**AMPLIFIER, R.F., No. 2
MODIFICATIONS
MODIFICATION INSTRUCTION No. 1**

MODIFICATION INSTRUCTION NO. 2

1. This instruction covers the modifications necessary when replacing condensers Y24A (C6A-D) by condensers Y24B, as used in the Amplifier, R.F., No. 2, Mk. II.

Fig. 1—Amplifier, R.F., No. 2, fitting of ceramic condenser Y24B

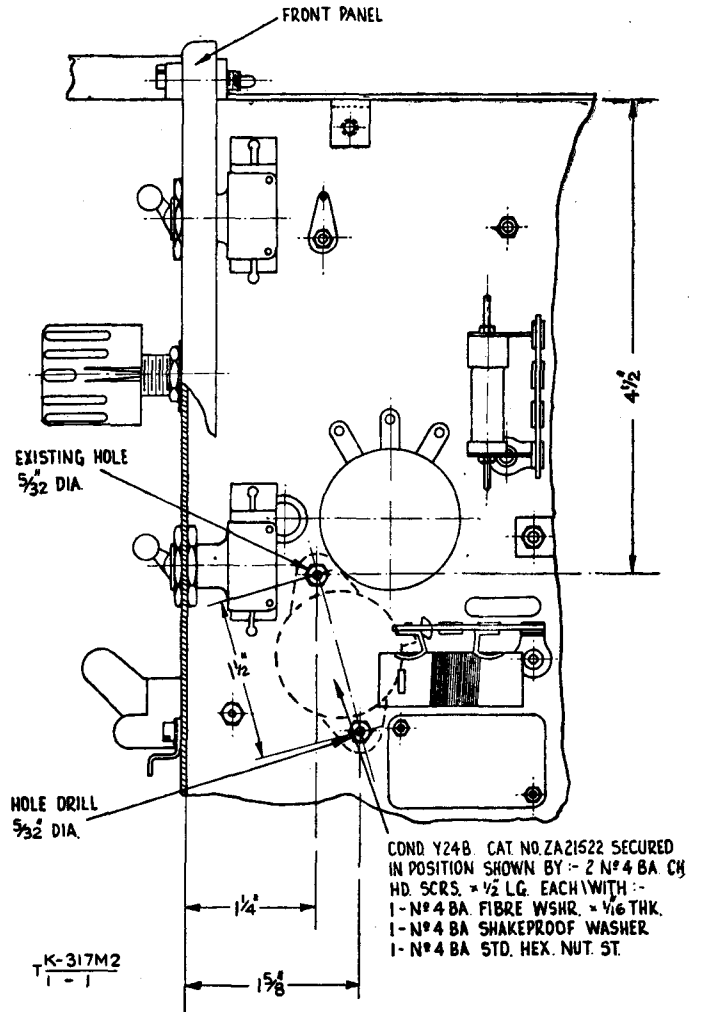
5. (a) Condenser Y24B has been fitted to Amplifier, R.F., No. 2, Mk. II, as the previous type of condenser (condenser Y24A) was not capable of withstanding the high R.F. voltage and temperatures encountered. Consequently it has been decided to provide the new type of condenser for the maintenance of Amplifier, R.F., No. 2, Mks. I and II. The following modifications will be necessary when replacing condenser Y24A by condenser Y24B.

- (d) Remove the input coil, L1A, to avoid damaging it in the subsequent drilling operation.
 - (e) Drill one hole $\frac{5}{32}$ in. dia. (22 drill) as shown in Fig. 1.

- (f) Mount the new condenser and connect up (normally the horizontal condenser tag is connected to the chassis end of the P.A. coil and the vertical one to the top end).
